# ADA Curb Ramp New Construction Inspection Form (Perpendicular)

NW Main

23885.56

NW Lenox

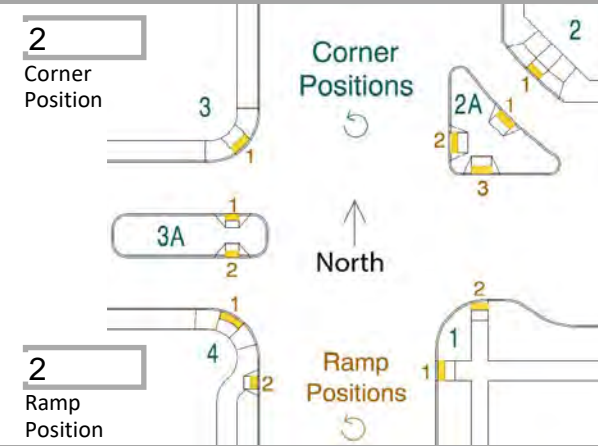
Counter Slope (+/-) \*2

6.9

☒

Slope Y

2.5

☒

DWS IITD Fails RR 1
